*BEACON PLANNING BOARD
One Municipal Plaza - Courtroom
BEACON, NEW YORK 12508
Phone (845) 838-5002 Fax (845) 838-5026*

The Planning Board will meet on **Tuesday, April 10, 2018** in the Municipal Center Courtroom. A work session will take place at 7:00 PM for a training workshop, discussion of agenda items and/or topics of interest to the Planning Board. The regular meeting will begin immediately thereafter, but not later than 7:30 p.m.

2. Townsend Street
Continue public hearing on the application for Subdivision Approval, 13-lot residential, 25 Townsend Street, submitted by AK Property Holding, LLC

On behalf of the Applicant for the above referenced project, Hudson Land Design (HLD) has enclosed five (5) revised plan sets, and one (1) electronic version of the full plan set (along with this response letter) based on comments received from the Planning Board and its consultants. We offer the following responses to each comment from your consultants:

ROAD EXTENSION PROFILE
 SCALE: 1" = 4' V
 1" = 40' H

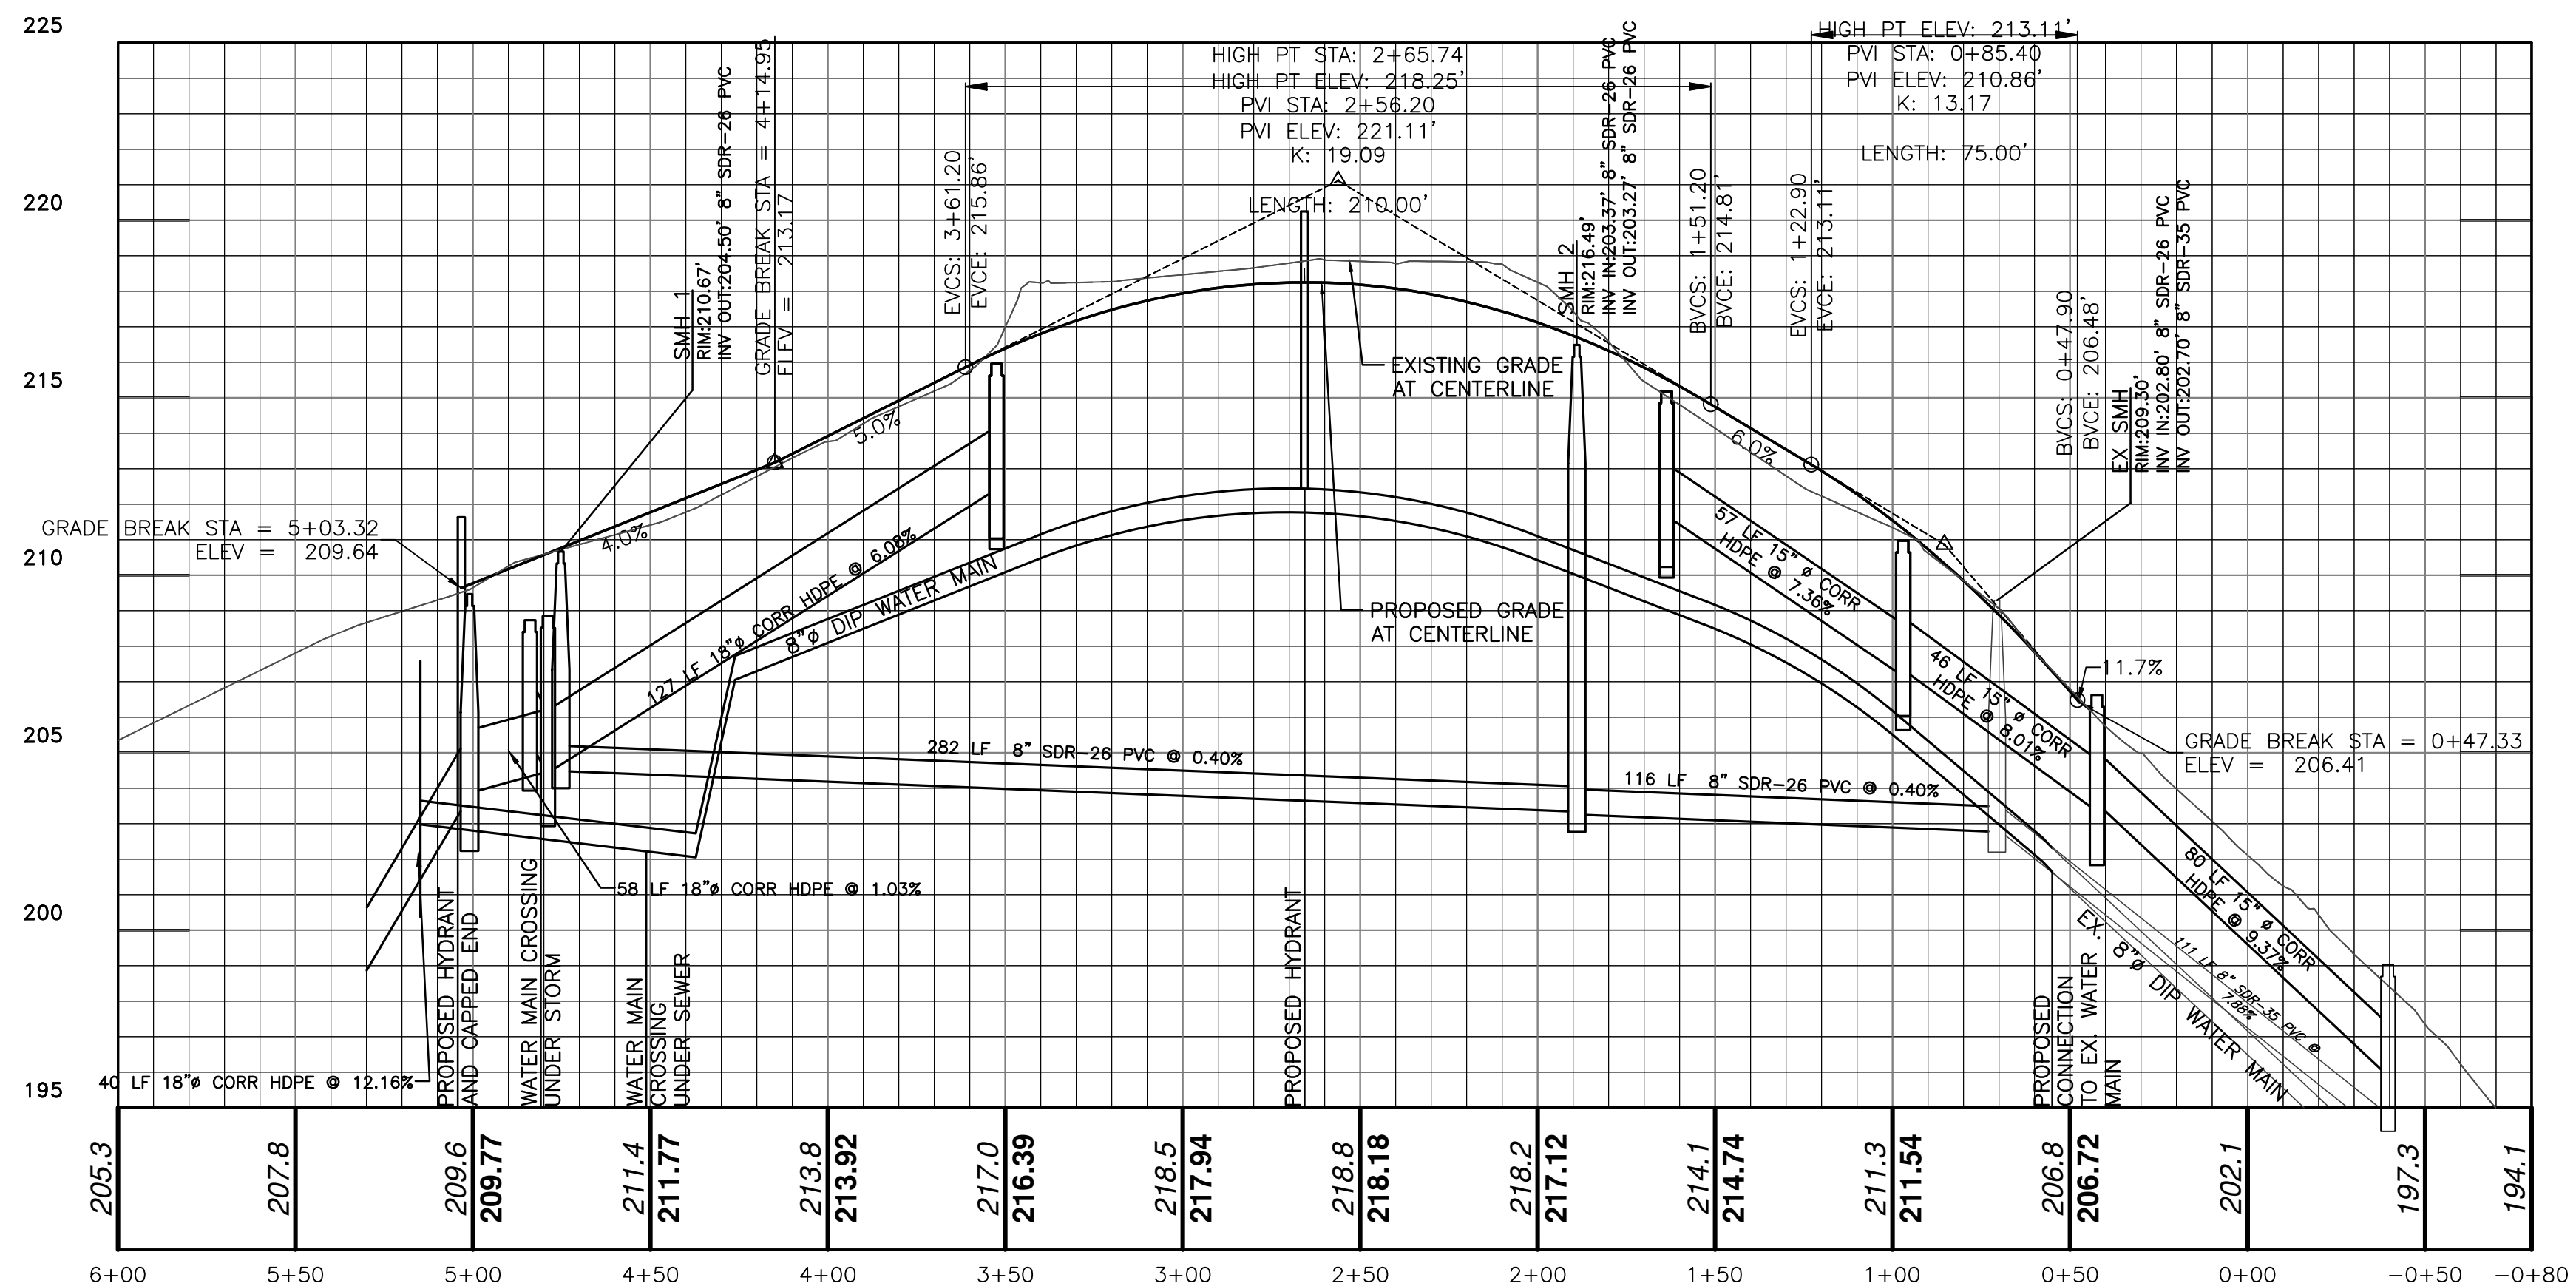
11. The road profile has been extended as requested using GIS 5' contour intervals. Based on the new profile, we do not believe the design should change, as it appears that the road grade will not exceed what is already shown. Please note that the 11.7% grade is an existing condition that the road extension has to tie into.

MONOLITHIC CURB AND SIDEWALK DETAIL
NOT TO SCALE

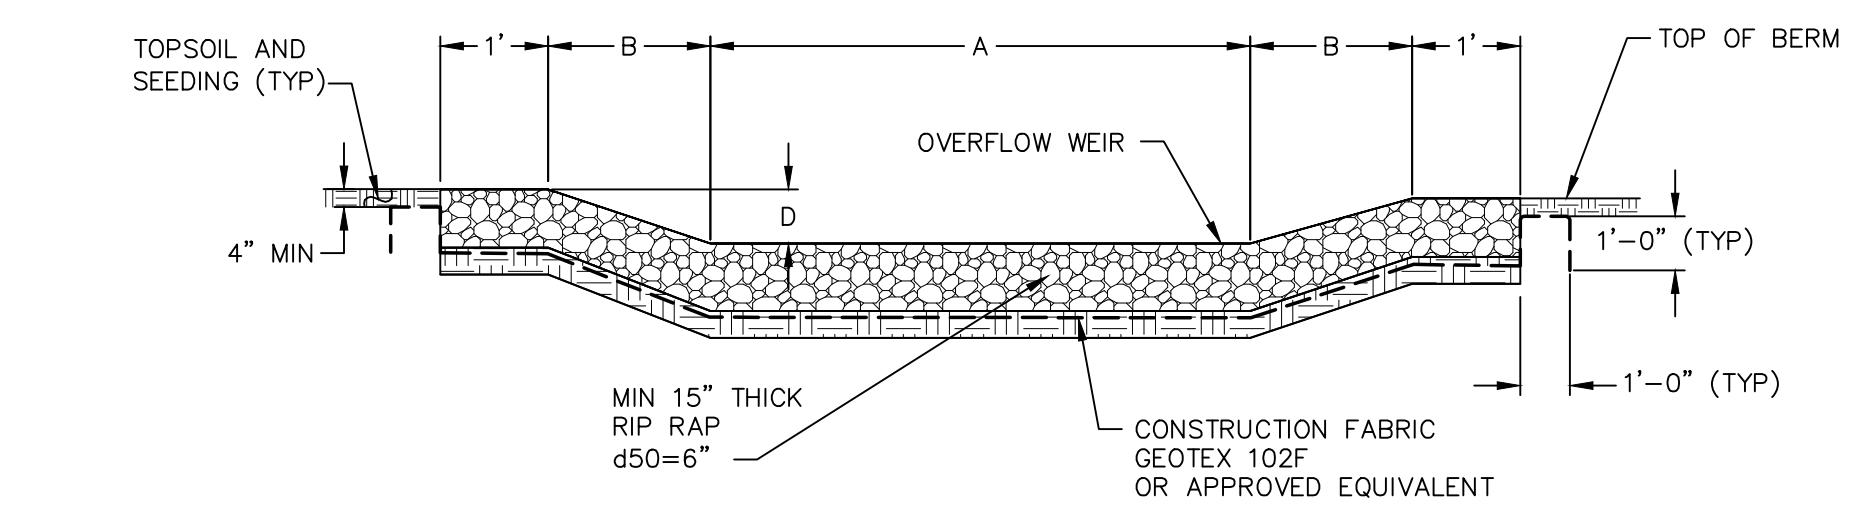
14. The "Local Street Cross-Section Detail" has been revised to reflect the use of NYSDOT Item No. 304.12. If an alternate detail is available for the desired road/sidewalk layout, we will add it to the plans.

STONE OUTLET SEDIMENT TRAP DETAIL
NOT TO SCALE

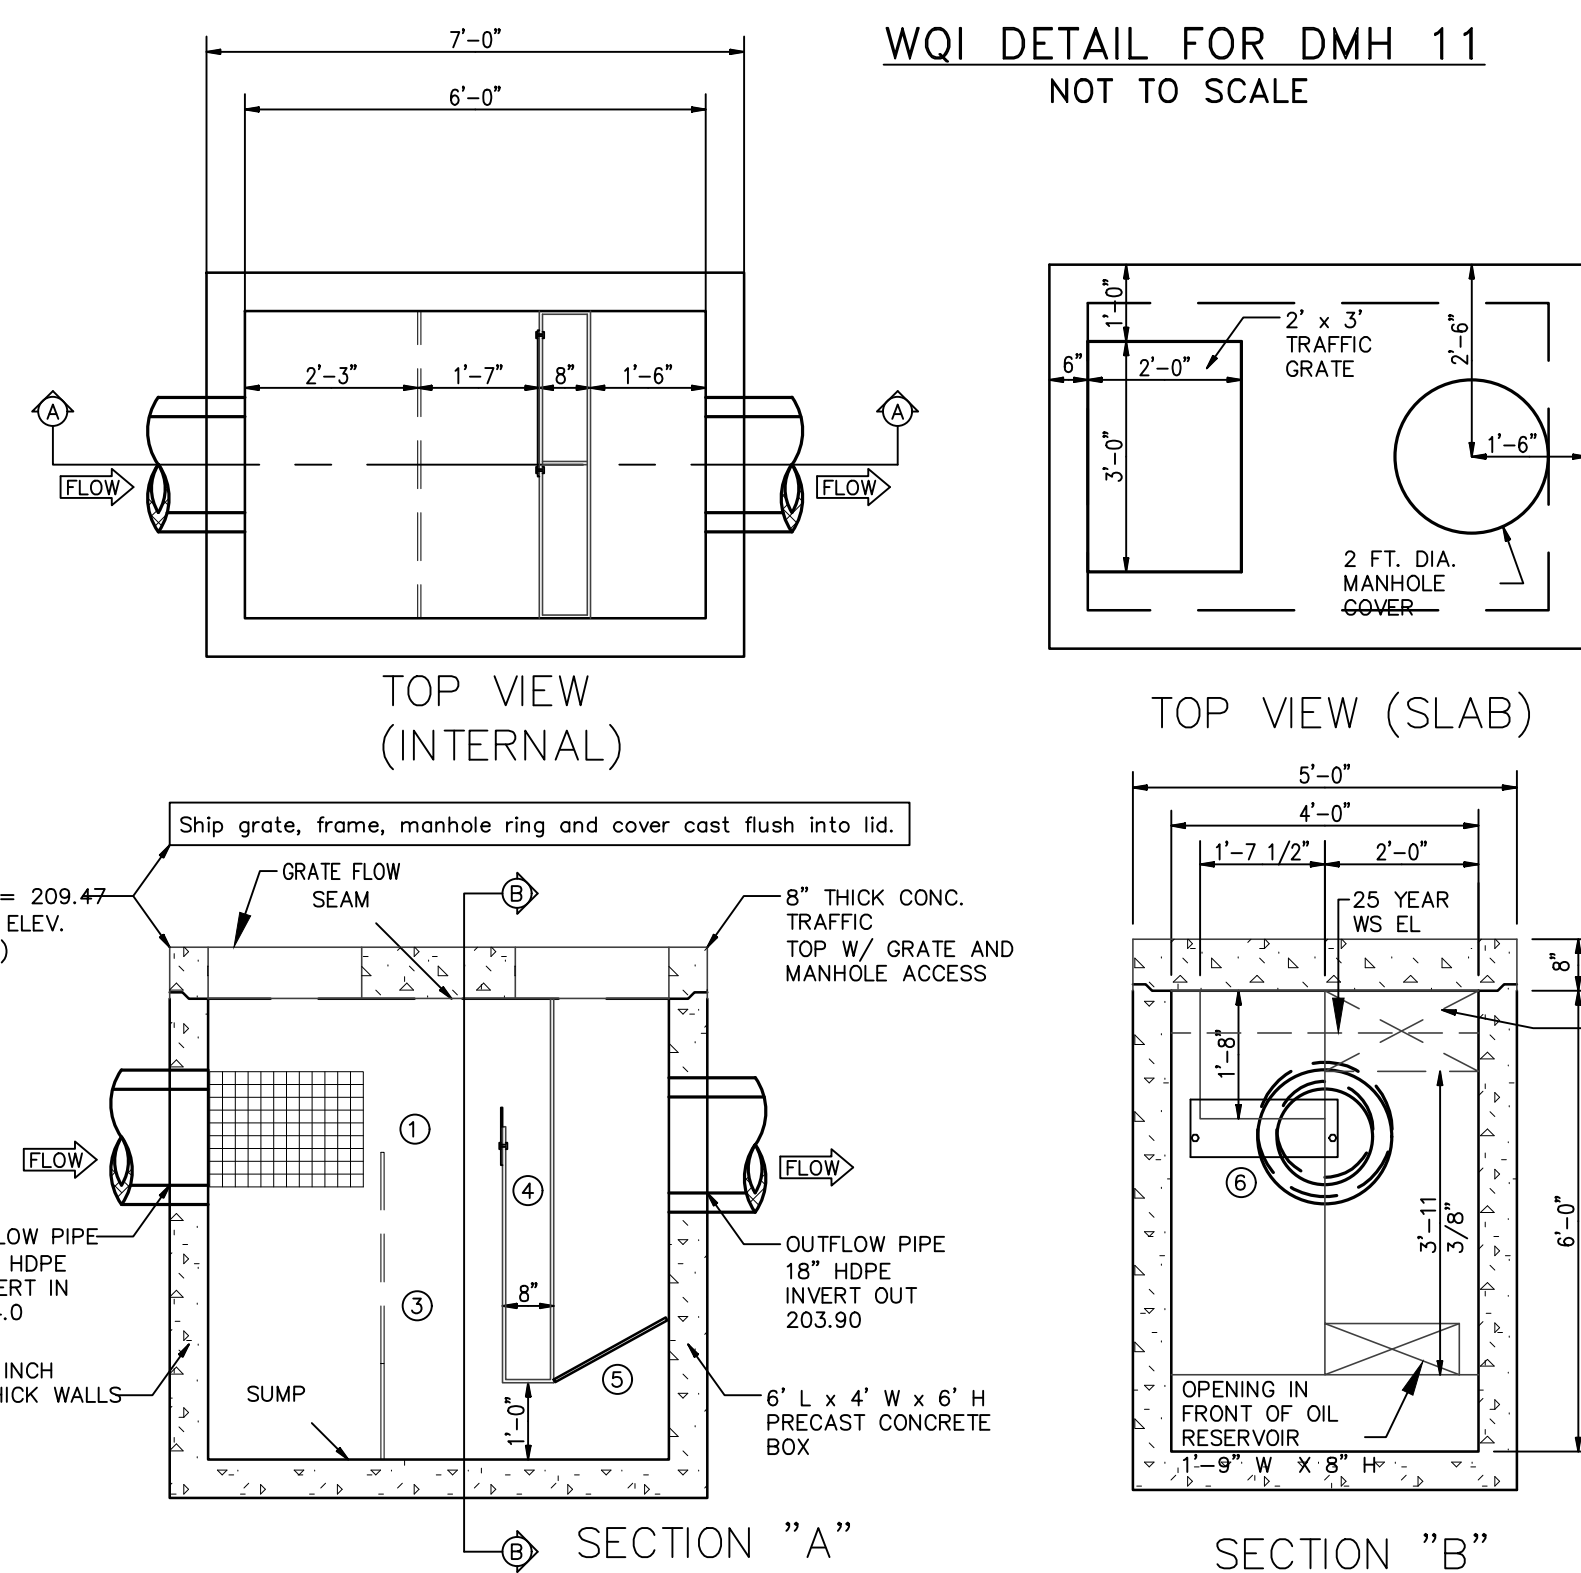
15. Grading for the diversion berm around the north side of the subdivision is now shown on the plans.
16. Sizing information for the temporary sediment trap is attached and a construction detail is now included on the plans.

HYDRODYNAMIC DEVICE DETAIL
NOT TO SCALE

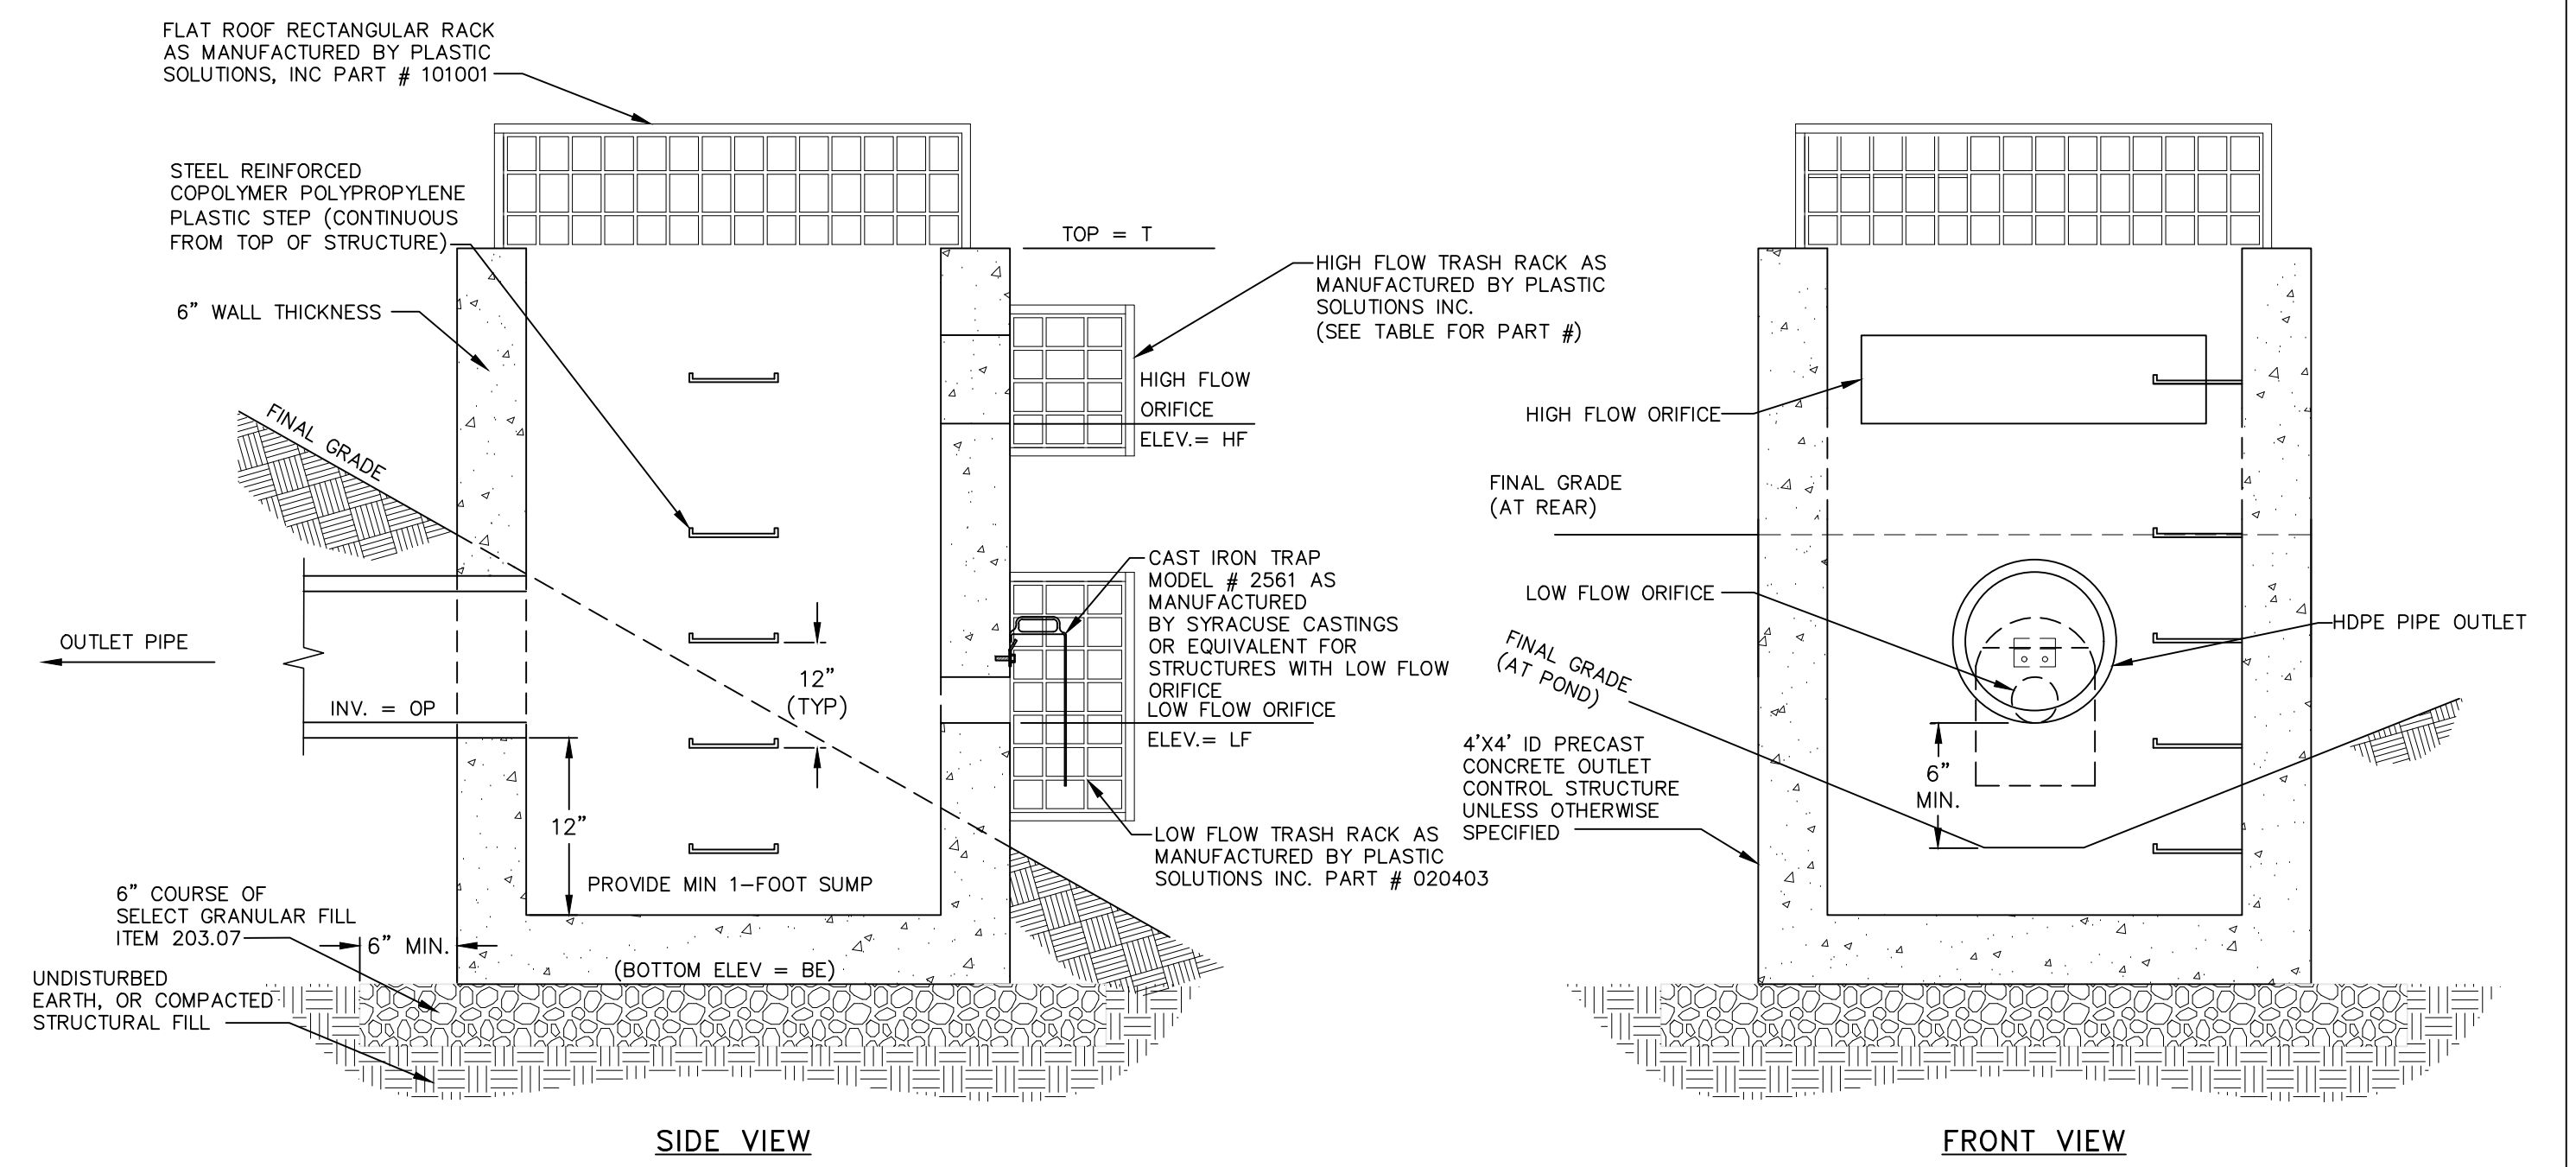
1. A final SWPPP will be provided with the final subdivision plans. Because we are considering this a redevelopment project, we are adding another hydrodynamic device near Townsend Street to meet the redevelopment requirements for water quality per the NYSDEC design manual.
